IMPORTANT SAFETY RECALL

NHTSA Recall No. 26V-006

Terex Utilities	
SAFETY NOTICE	SN735

SUBJECT: Upper Control Valve – Enable Cavity Plugs

• **Figure 1 - Typical location to inspect of upper control valve enable section**

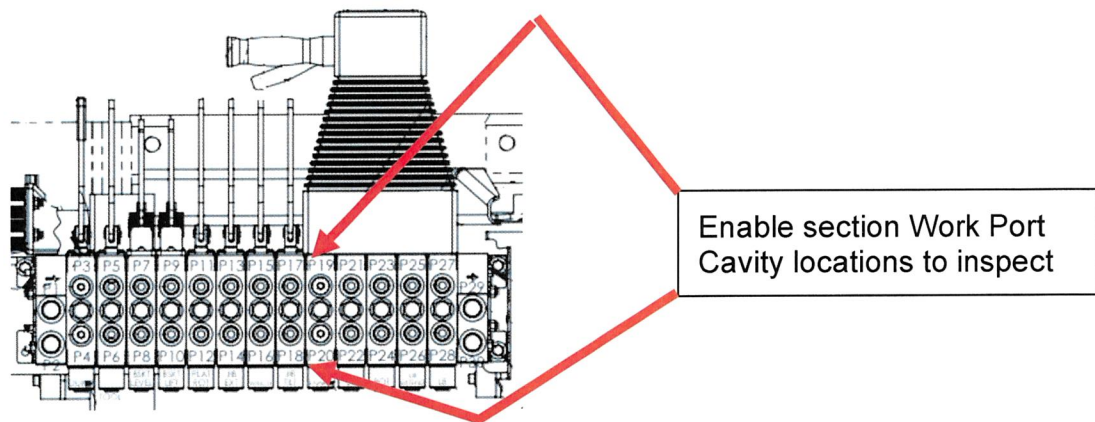
There are three methods to determine if a unit is subject to this recall. In doubt use method 2 to determine if the correct plug is installed in the enable section work port cavities or if Z1765 is required. Position the platform and rotate the platform out if needed, and remove covers if necessary to see the upper control valve as shown in Figure 1.

2. Position the platform where you can look at the upper control valve. Shut off the engine and relieve the pressure by depressing the STOP control at the platform. Position a pan or rags to collect oil spillage and remove the upper and lower work port cavity plugs from the enable section using a 5/16 Allen-Wrench as pointed out in figure 1. If the plug is an NR plug as shown in figure 3 replace with standard plugs as shown in figure 2.

Perform one or more of the inspections above. Refer to the pictures below for clarification. If the plug are black in color or verified by visual examination the incorrect plug is installed and must be removed and replaced with a standard SAE 10 Hollow Hex Plug, 411585 included in Z1765. Fill in the completion record included with the owner letter and return.

Figure 2 – Correct Plug in the enable section cavity locations as shown above.

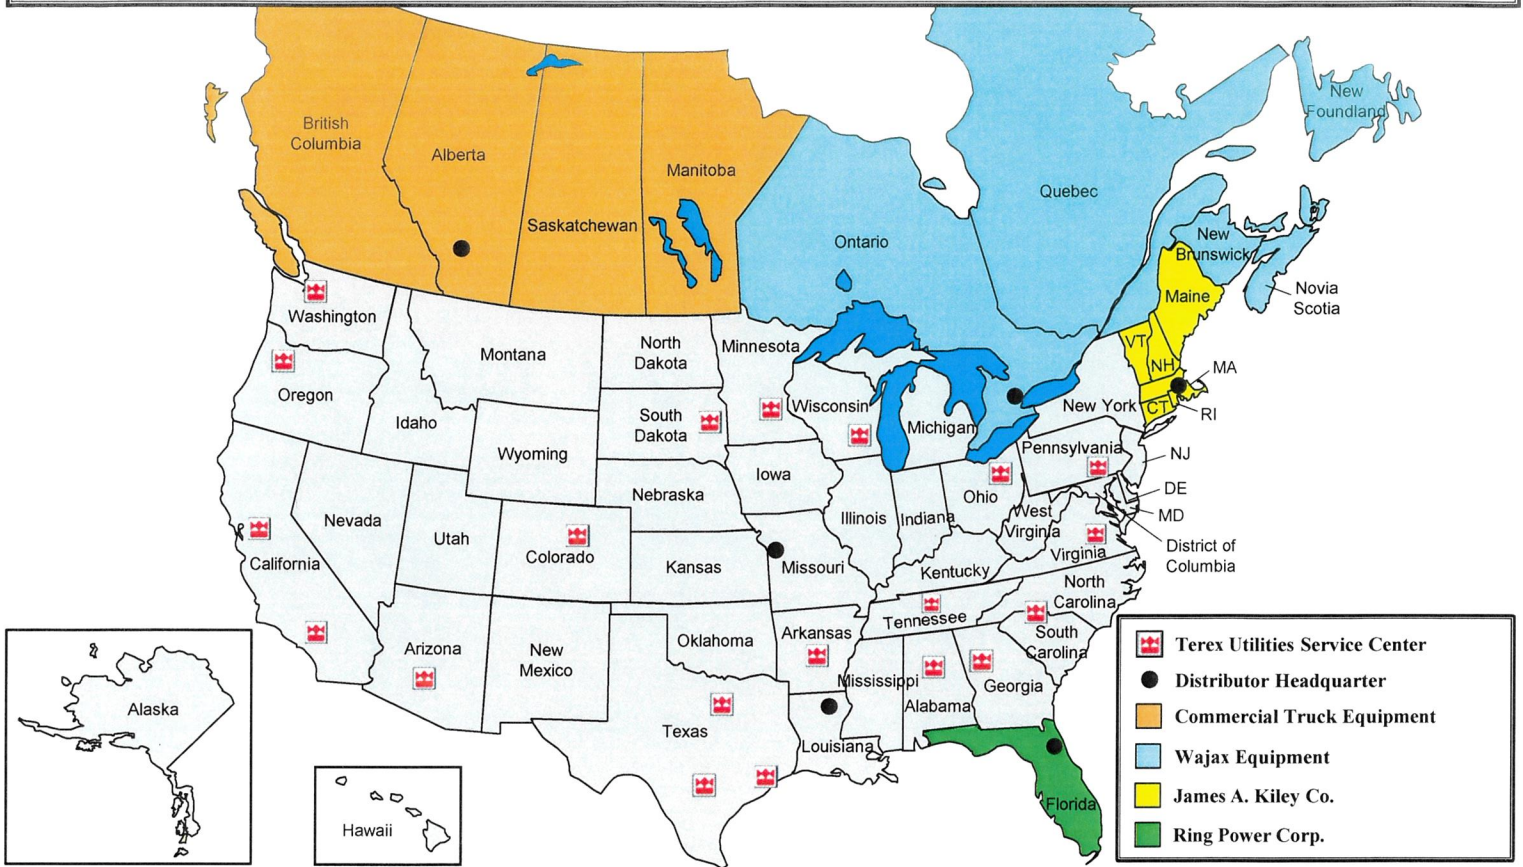
08MB Hollow Hex plug 411585 Color is silver
